RE: REVISED GRADING & DRAINAGE PLAN, TRACT 1  
CLIFFORD INDUSTRIAL PARK, RECEIVED AUGUST 29, 1988  
FOR FINAL PLAT APPROVAL (C-17/D1U)

RE: GRADING & DRAINAGE REPORT SUBMITTAL OF CLIFFORD INDUSTRIAL  
PARK, TRACTS B-2, B-3, & B-4, RECEIVED MAY 13, 1988  
FOR FINAL PLAT APPROVAL (C-17/D1U)

RE: REVISED DRAINAGE REPORT OF WASHINGTON BUSINESS PARK,  
RECEIVED MAY 30, 1986 FOR PRELIMINARY PLAT APPROVAL  
(C17/D1U)

#### CLIFFORD INDUSTRIAL PARK TRACTS C-N & WASHINGTON BUSINESS PARK LOTS 5, 6A, 7, 8A & 9-16 GRADING & DRAINAGE REPORT

# CALCULATIONS

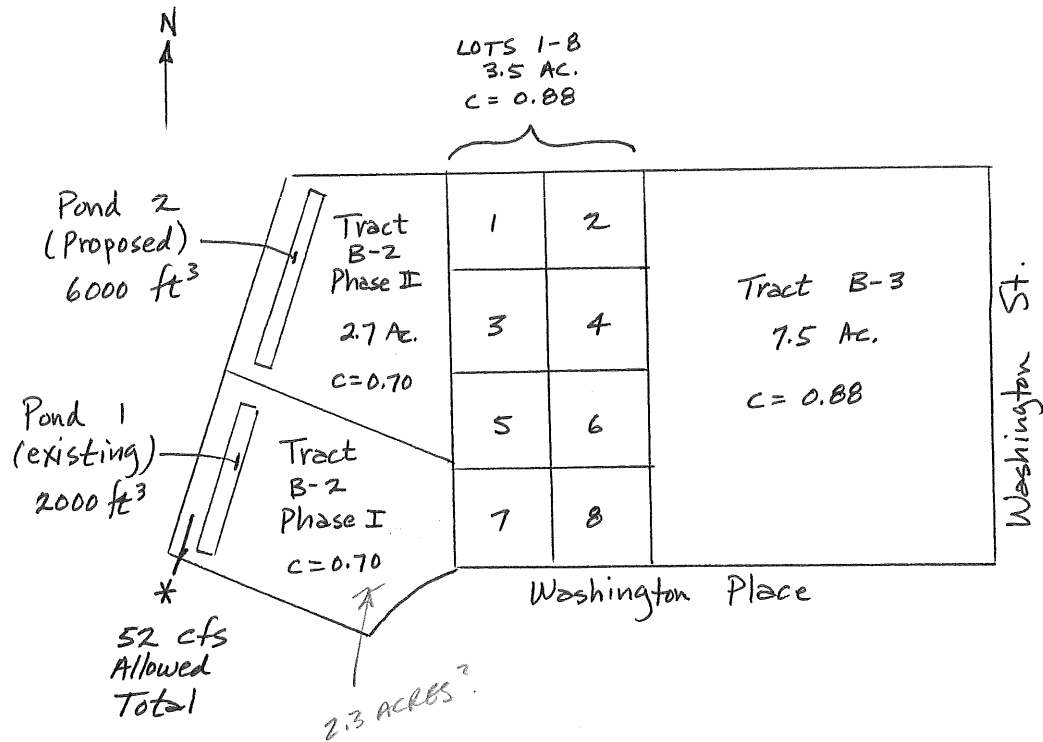
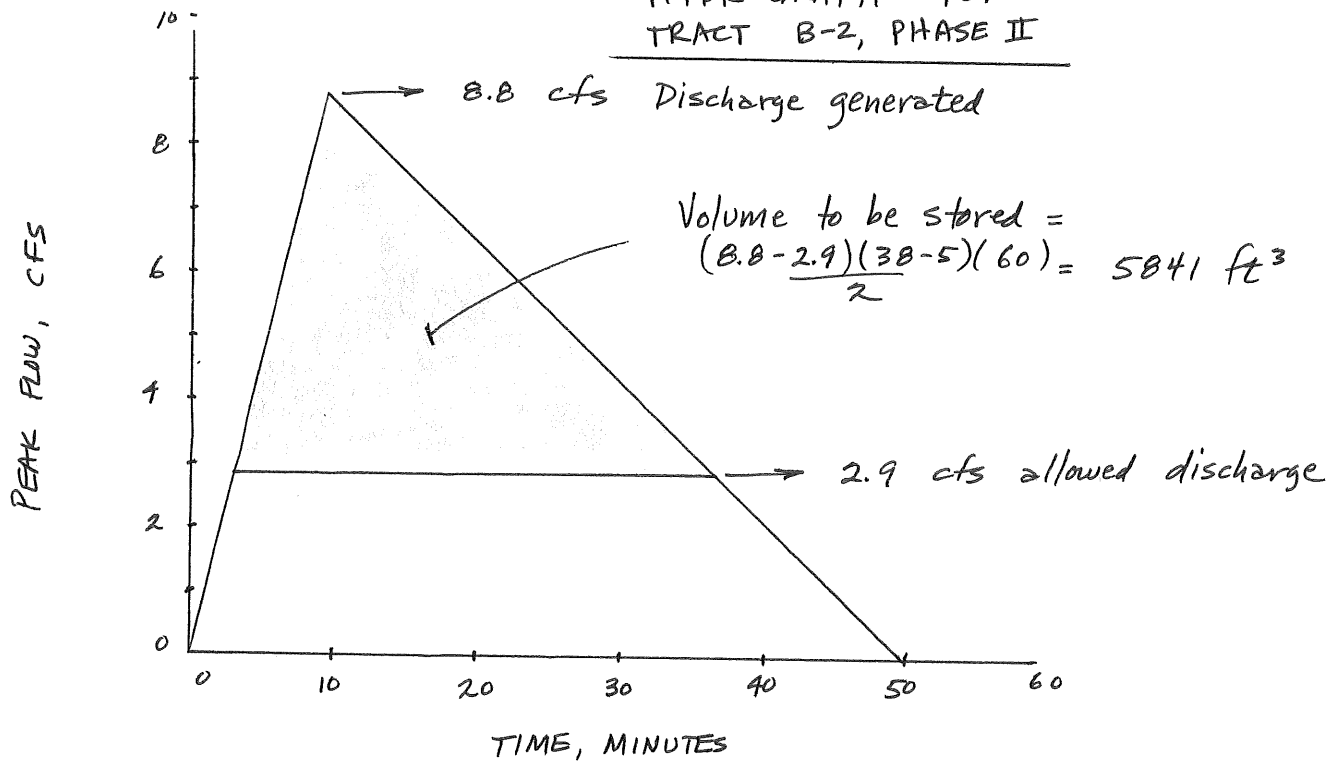
This is a request for a variance from the Master Drainage Plan (Bohannon-Huston, August 1982) for Clifford Industrial Park (Zone Atlas C-17).

We are proposing developing the remainder of the site so that the total developed peak discharge will be in compliance with the Master Plan. This will be accomplished as follows (see accompanying calculations):

- ° Lots 1-4,  $C = 0.88$
- ° Tract B-3,  $C = 0.88$
- ° Tract B-2, Phase II,  $C = 0.70$
- ° Construction of a detention pond on Tract B-2, Phase II, which along with a similar pond existing on Tract B-2, Phase I, will limit discharge from the total site (16 acres) to an acceptable peak rate.

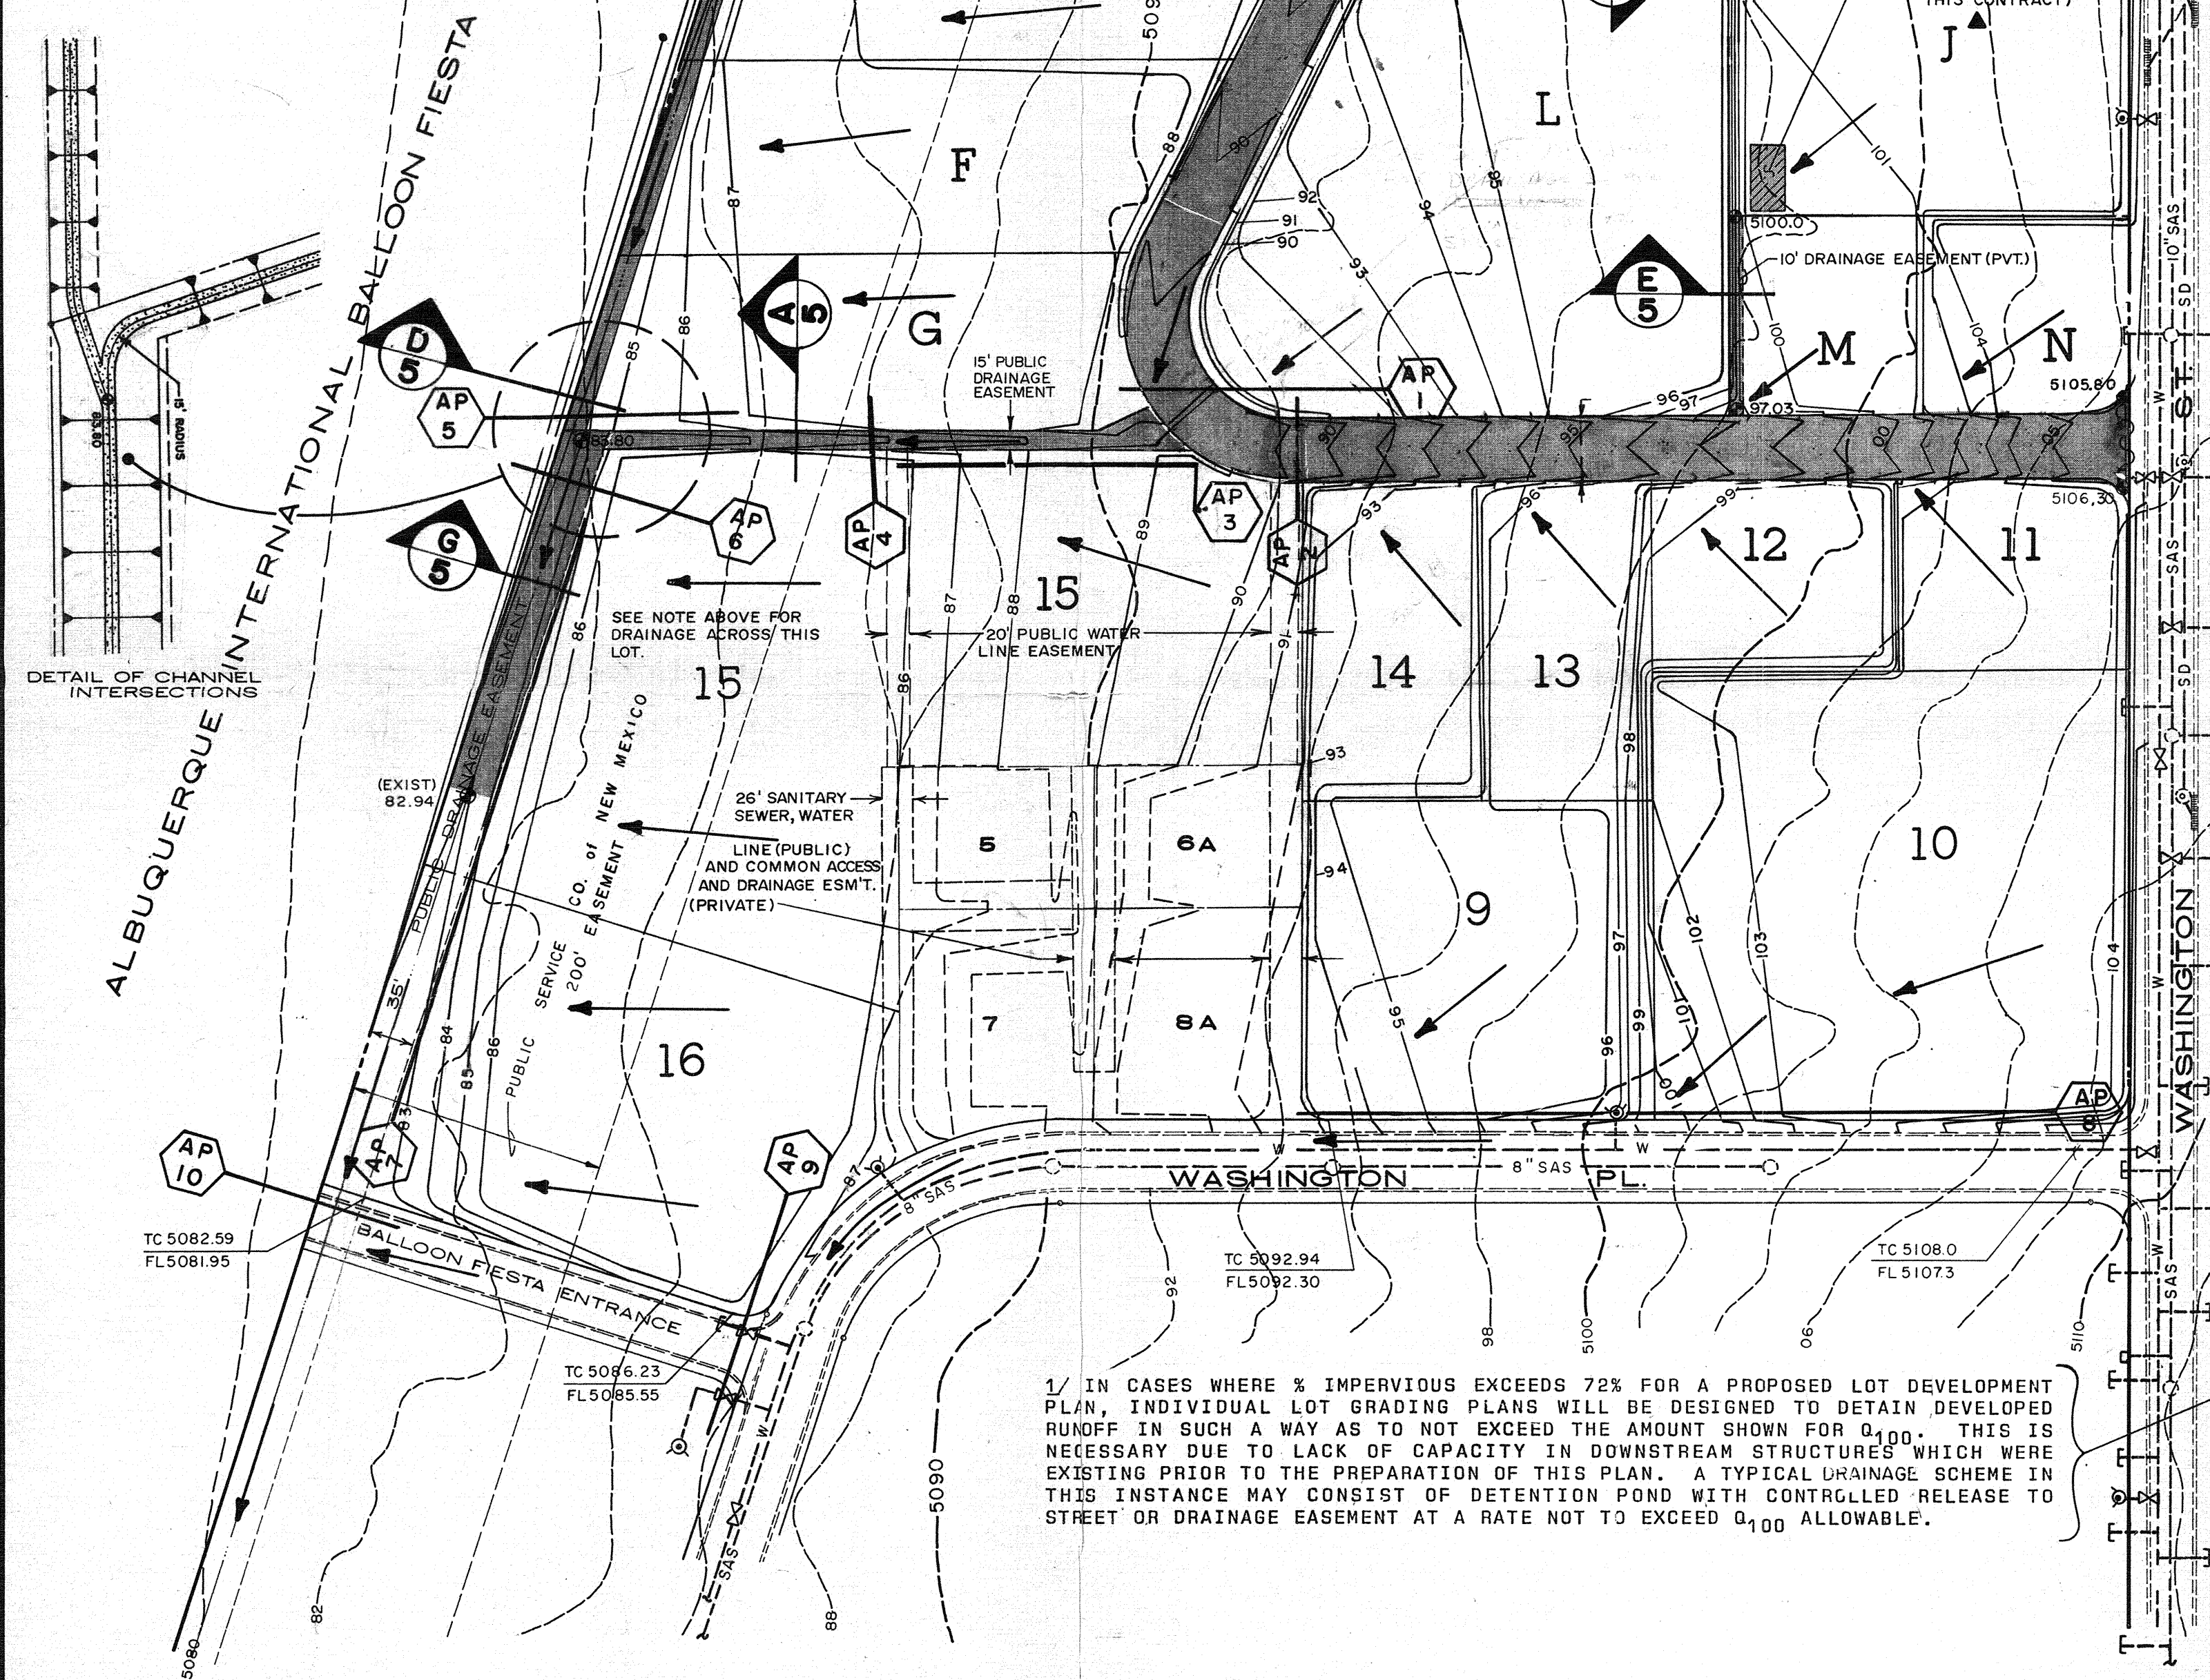
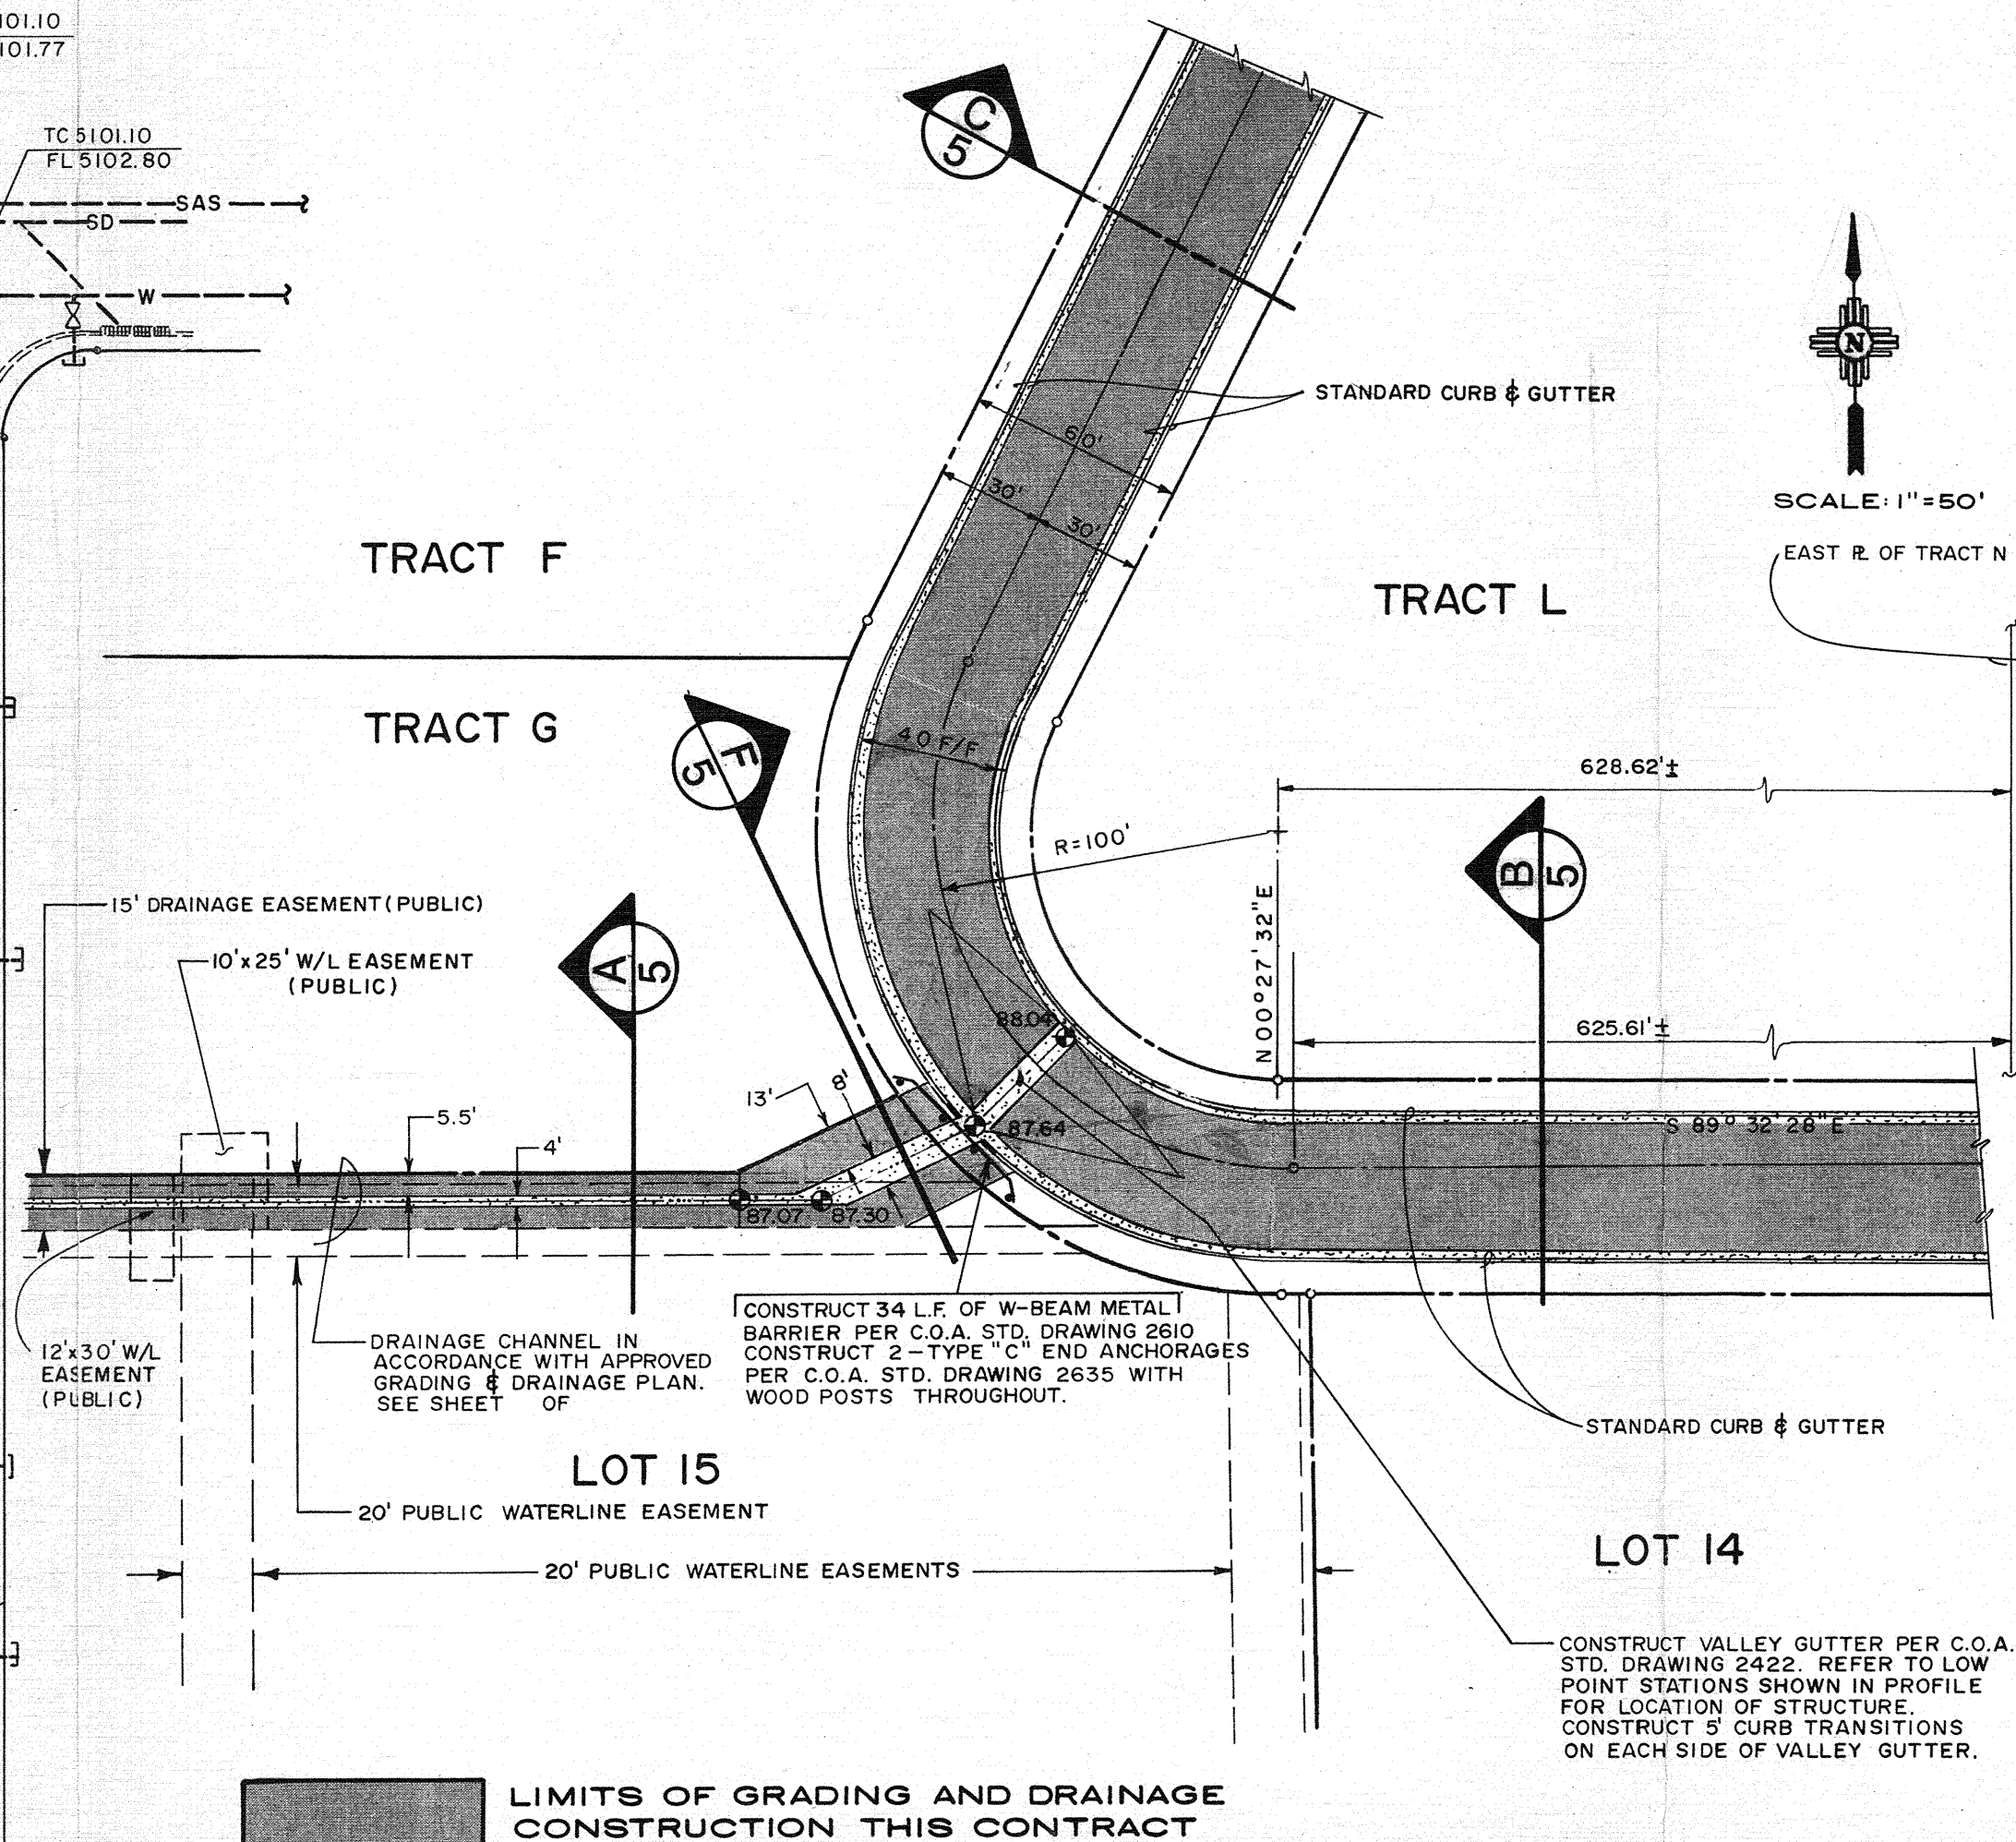
The above referenced submittal, revised August 8, 1988, is approved as the Master Drainage Plan to be followed for subsequent development and subdivision. Any proposed subdivisions will require an executed Subdivision Improvements Agreement prior to the City Engineer's sign-off on any Final Plats if infrastructures are required.

All site development of lots will require a separate detailed Drainage and Grading Plan submittal, with the drainage scheme being consistent with this approved plan.
